December 8, 2020

RE: Peer Review Response to Comments
Proposed Residential Development
Rockland, Massachusetts

McMahon Associates has completed a review of the Traffic Peer Review comments completed by J. Gillon Associates dated July 27, 2020 regarding the Pond Street Apartments (since named Shingle Mill Multi-Family Development) proposed to be located at 75 - 79 Pond Street in Rockland, MA. The purpose of this letter is to provide responses to the most recent comments provided by J. Gillon Associates based on the Traffic Impact Study (TIS) McMahon completed for Coneco Engineers and Scientists in November 2019.

FIGURE 1 - 2026 NO BUILD WEEKDAY PM PEAK HOUR VOLUMES

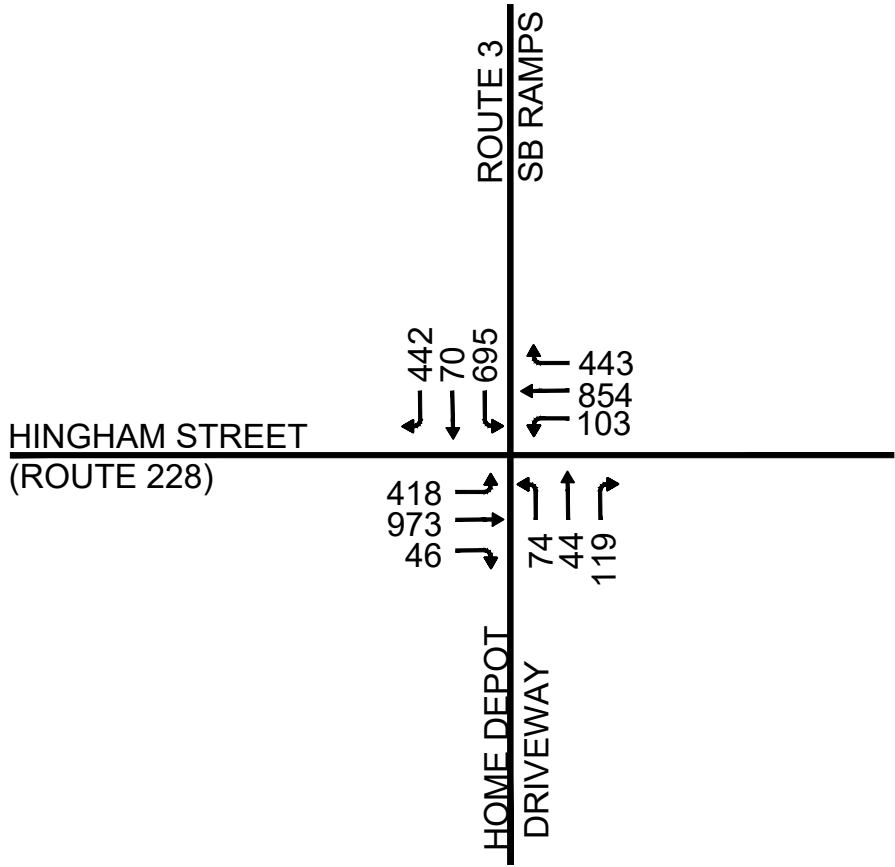
The proponent has clearly documented that their 80 vehicle trips during the morning peak hour and 101 trips during the evening peak hour would not in and of itself overload the Hingham Street signalized intersections. However, my point was not to document the incremental increase in volume and delay for Rockland residents but was intended to document the corridor volumes and signal demands so the Town is assured the corridor is operating as efficiently as possible and further, to provide a baseline condition for other developments which may be introduced beyond this project. While the actual percent increase in volume and delay may be acceptable, it would be beneficial to identify the projected best signal operating condition at the southbound ramp intersection.

inflating the Home Depot generation. Bear in mind that it is not so important to precisely evaluate the southbound ramp intersection as it is to identify if the corridor signal system could operate most efficiently. Therefore, I continue to encourage the proponent to add this intersection to their Study Area.

If these traffic signals are of the newer adaptive control type where the internal mini-computer controller can adjust the timing of their green light cycles to match current traffic conditions on the ground where they are constantly collecting data about approaching vehicles and creating new timing sequences to match them, they should indicate the State is willing to maintain this system. It is therefore my opinion that the intersection of Hingham Street (Rte. 228) at the southbound Route 3 Ramp/Home Depot Driveway should be added to the Study Area.

To remain consistent with the methodology presented in the TIS prepared for the Shingle Mill Multi-Family Development, the 2024 projected traffic volumes were grown by 1.5% compounded annually to reflect 2026 No Build conditions which were used as a basis of the supplemental traffic analysis. The 2026 No Build weekday

afternoon peak hour traffic volumes for the intersection of Hingham Street (Route 228) at Route 3 Southbound Ramps/Home Depot Driveway are shown in Figure 1 attached.

FIGURE 2 - DIRECTION OF ARRIVALS AND DEPARTURES

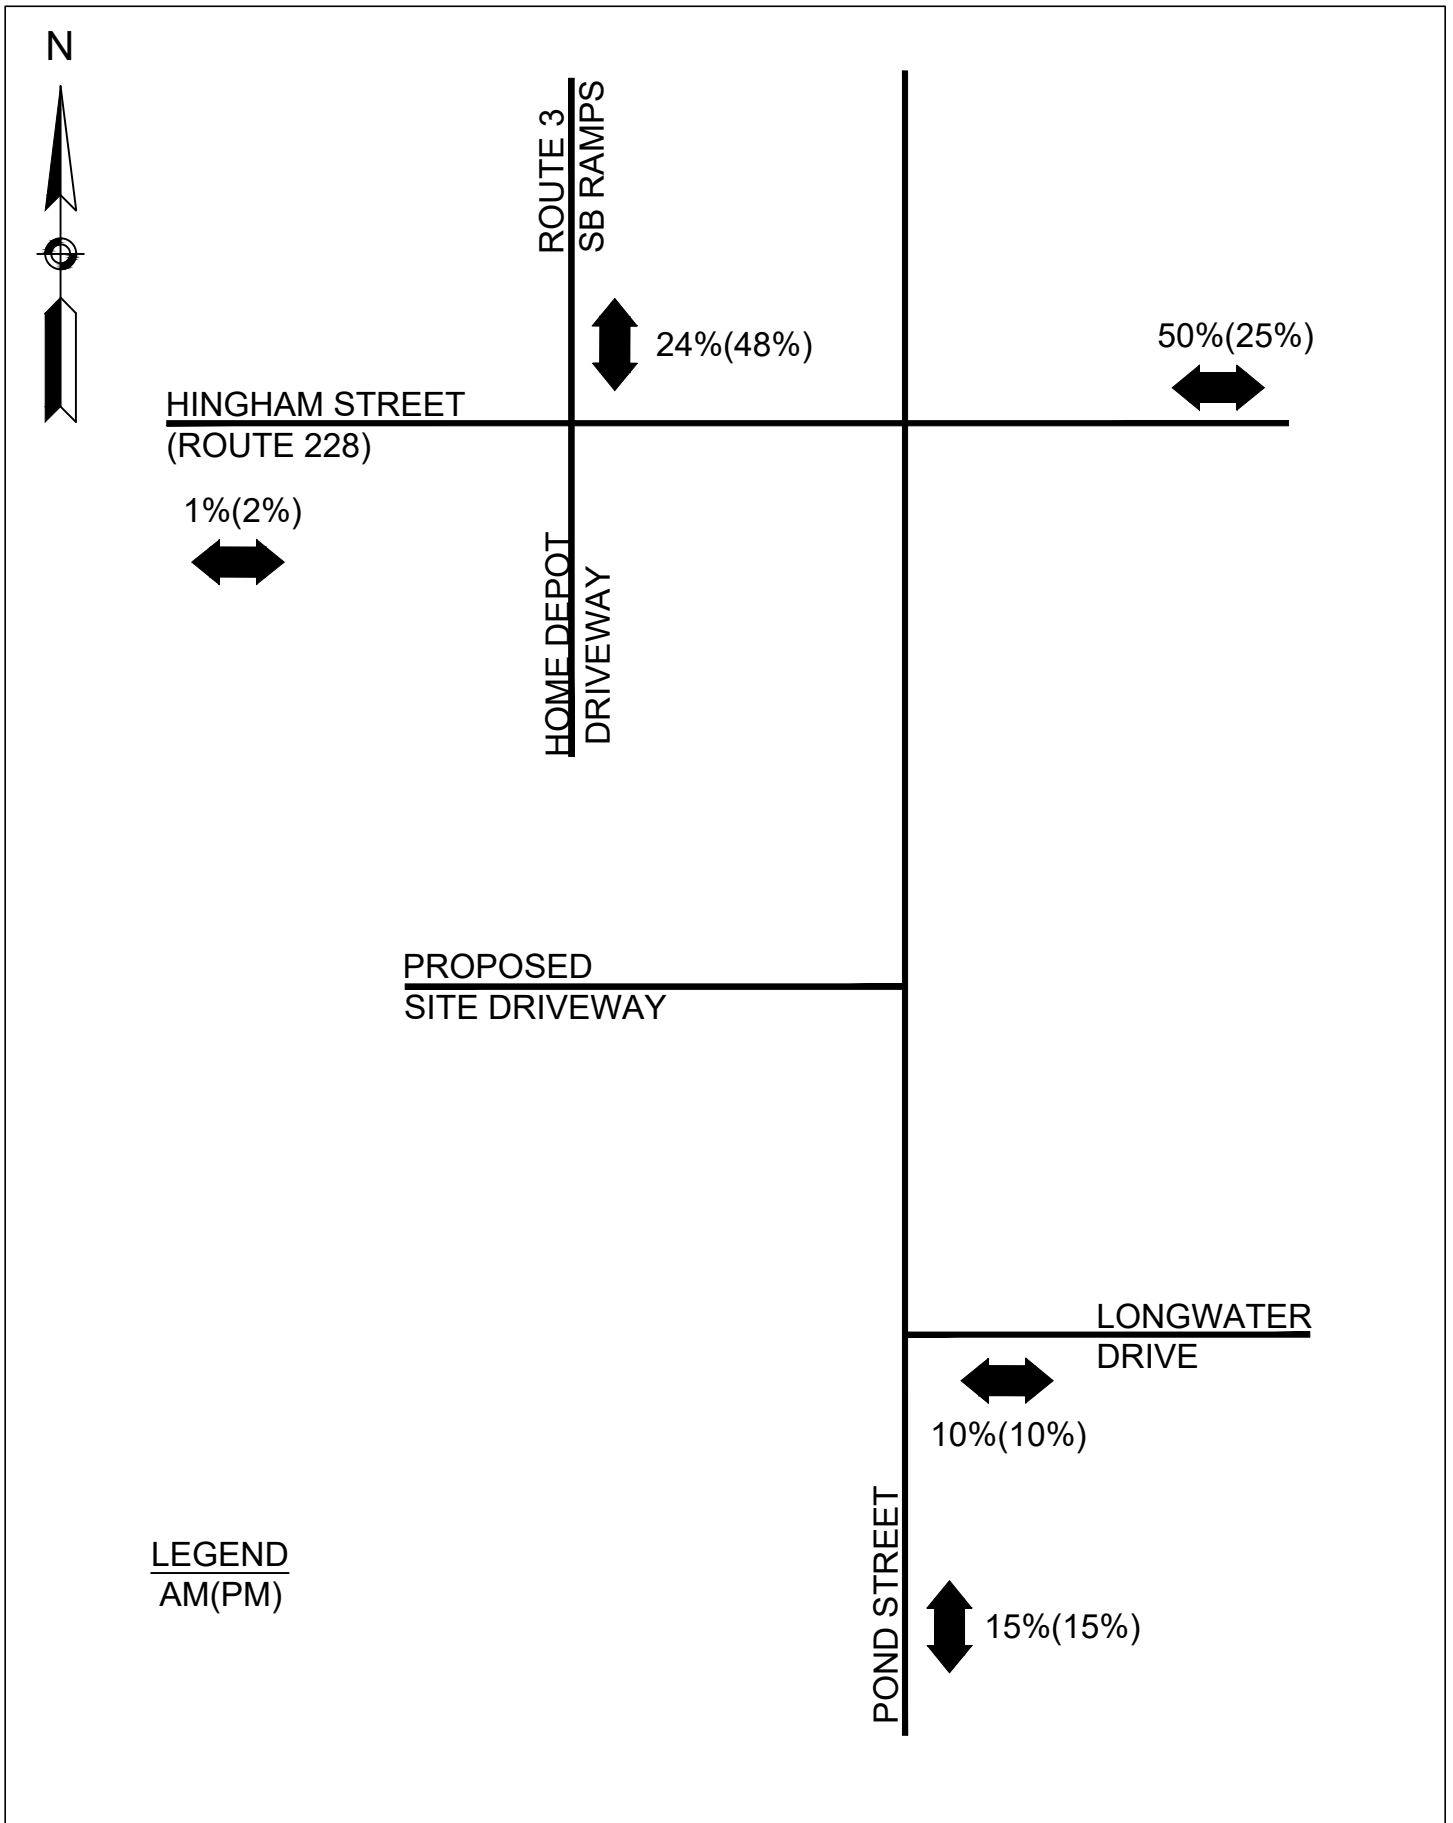
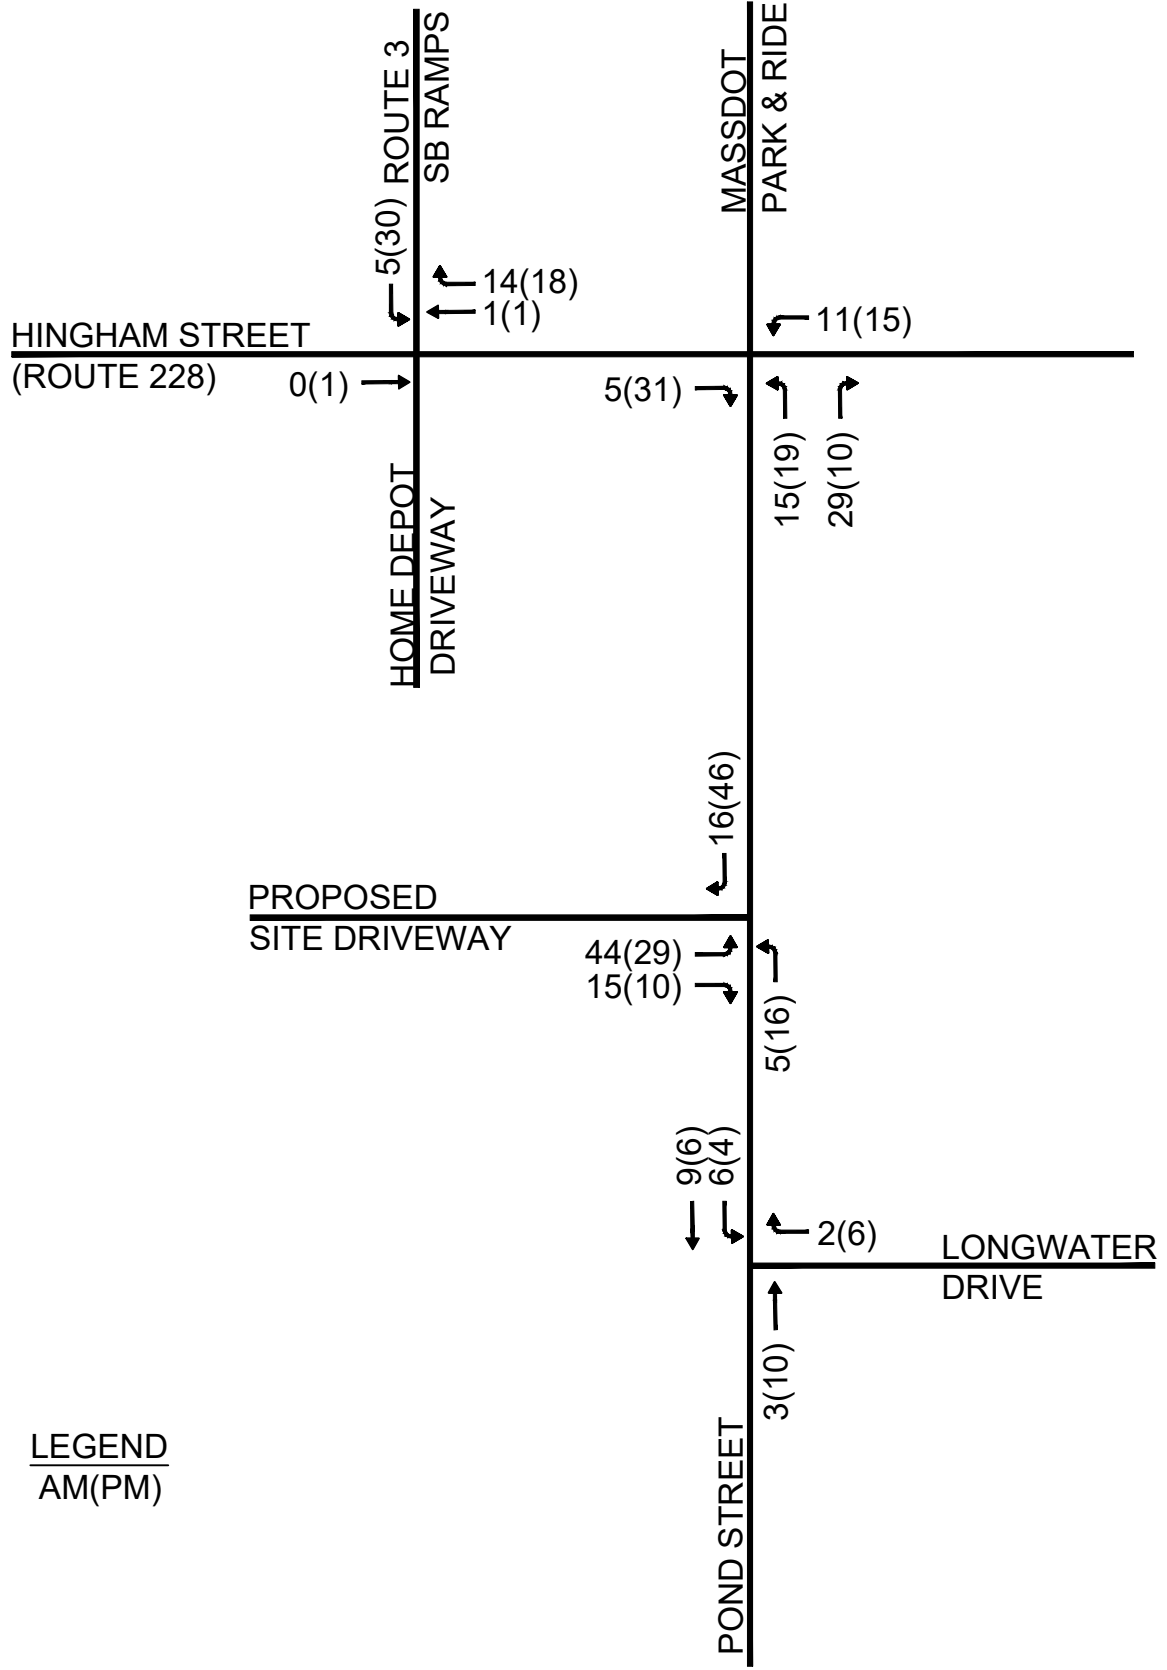
The Proponent appears to indicate that while revising the trip assignments to reflect a Route 3 return trip via the Southbound Route 3 ramps and Union Point Commuter Rail Station is possible, a 25% change in either direction would only amount to approximately 25 trips and therefore would have no significant impact.

Again, I am not questioning the signal systems ability to process these vehicles but merely suggest the final report should reflect the expected volumes to assure the system is operating as efficiently as possible and provide a baseline network flow for other projects which may follow if we are not able to identify post covid-19 volumes for a while.

The vehicular trips associated with the proposed residential development were distributed through the intersection of Hingham Street (Route 228) at Route 3 Southbound Ramp/Home Depot Driveway based on existing traffic patterns and logical travel routes, while accounting for the configuration of the Route 3 ramps in relation to the predominant movements during both the weekday morning and weekday afternoon peak hours within the study area. The resulting project arrival and departure patterns within the study area are presented in Figure 2 and the resulting distributed new project trips during the weekday afternoon peak hour are shown in Figure 3.

The capacity analysis conducted for the intersection of Hingham Street (Route 228) at Route 3 Southbound Ramps/Home Depot Driveway presented in Response to Comment I incorporates the updated trip distribution patterns.
